W0129-03

re: Clarification to notice in accordance with Article 16(1) of the Waste Management (Licensing) Regulations dated 23 March 2012

Proposed Landfill Cells Superimposed on Site Geology		A4
Location: Hollywood, Naul, Co. Dublin		JM
Client: Environmental Protection Agency (EPA) Ireland		MF
00146-014/JM	March 2012	00146-014

Figure 2

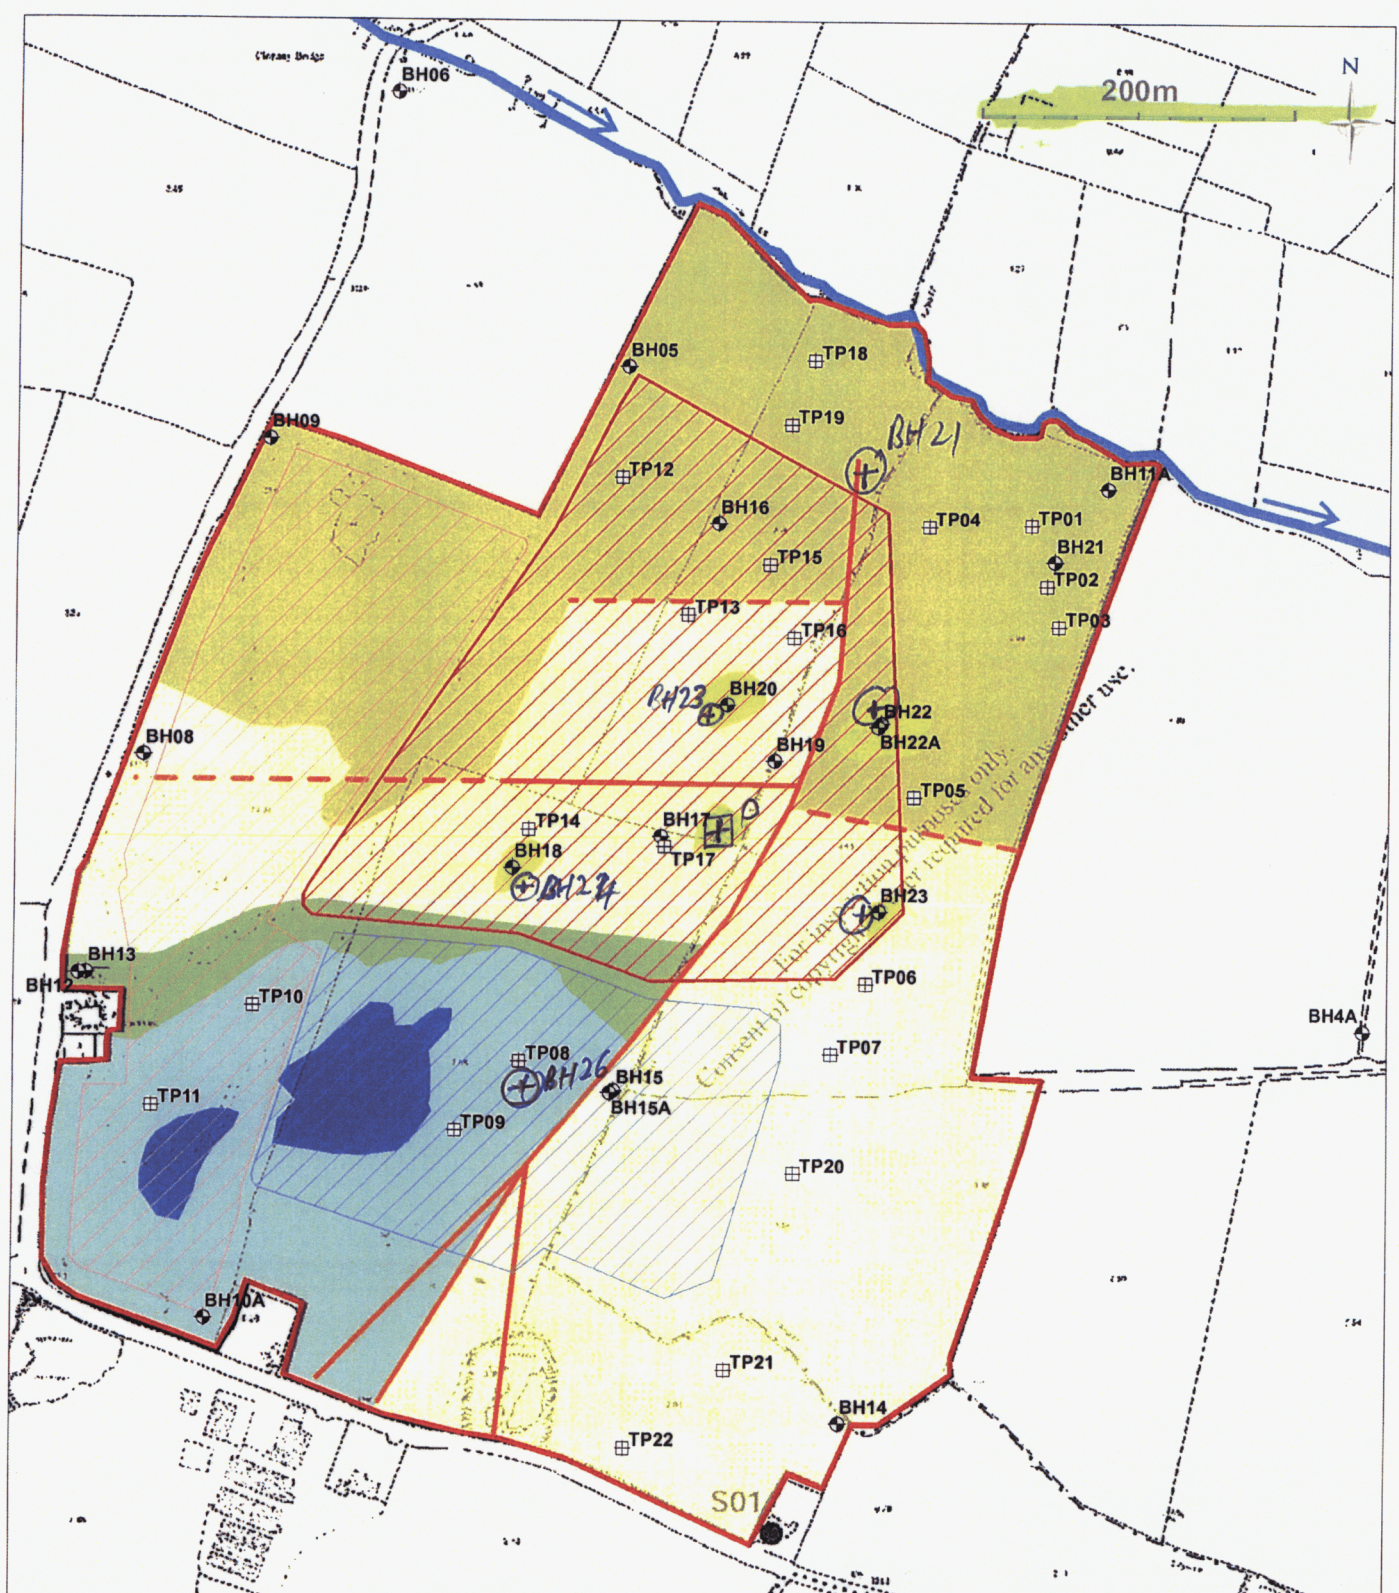
The proposed scope is not ideal and it is recommended that it be adjusted as set out below. The attached diagram illustrates the recommendations.

The four "well pairs" to be located in the four apparent fault blocks should not be so far apart. It may be preferable to have data points within 100-200m of each other. Therefore we suggest the following:

1. BH23 should not be next to BH16, but BH20. BH16 was drilled to 60m and did not report Loughshinny (it was cored so there's good data) and therefore another 60m well in this location will not "bottom out" the Loughshinny. It is considered that it may be better to have this second well closer to the fault system and therefore beside the existing well BH20. BH20 was not cored but is reported to be screened at the base of the Namurian. Therefore a second, deeper well targeting the Loughshinny should work at the BH20 location.

2. BH22 should not be in the northeast corner (too remote and Loughshinny apparently too deep). It may be appropriate for a new well pair to be installed close to the shallow borehole locations BH22/22A (in unconsolidated materials). It may be appropriate to install these two new wells to ~40m and ~60m depth and screened appropriately to be able to target the Namurian and Loughshinny, respectively.

3. BH24 next to BH18. BH18 appears to be screened in the Loughshinny at about 16-21m depth. It may be appropriate to install BH24 to 15m deep and screened between 5-15m (or thereabouts).

4. BH25 should not be in the southeast corner (too remote). A new well pair close to the shallow borehole location BH23 (in unconsolidated materials no water strikes to 23m depth) may be preferable with two new wells installed to ~40m and ~60m depth and screened appropriately to be able to target the Namurian and Loughshinny, respectively.

1. The well in the non-hazardous cell (BH26) might better serve as a monitoring well, not the pump test well.
2. Proposed well to the north (BH21) targeting the fault zone. It may be preferable for this well to be closer to the suggested end of this north-south fault (on your plan) and not at the north boundary of the site. It is designed to intercept the fault zone in this area. With this as the target our sense is having two wells one to 40m depth (screened 20-40m) and a second to 60m (screened 40-60m) may be better than the 90m option, recognising we may not reach the Loughshinny.

3. The pump test well may not usefully be BH26 (believed to be too remote from the main fault block intersection and area). The original pump test well (BH17) location was good, it was just the well was screened across the Namurian and Loughshinny so not that useful in this sense. Therefore it may be that a new pump test well about 25m east of existing BH17 (not too close to it) towards the main north-south fault, but not too close to it, is appropriate.

Not all boreholes need to be cored. However at the proposed locations near existing boreholes BH20, BH22/22A and BH23, coring the deep borehole would help a lot to understand the geology and aquifer units and fracture distribution and therefore could be invaluable. The pump test well might also of course benefit from being cored. If four is seen as prohibitively expensive then it may be appropriate that the pump test plus one of the two boreholes to the east of the main fault are prioritised for coring (so 2 not 4 cored).

It is noted that the MEHL numbering system for the proposed new wells should be changed as there are already boreholes with the same reference (e.g., BH22 and BH23) which will be confusing later.
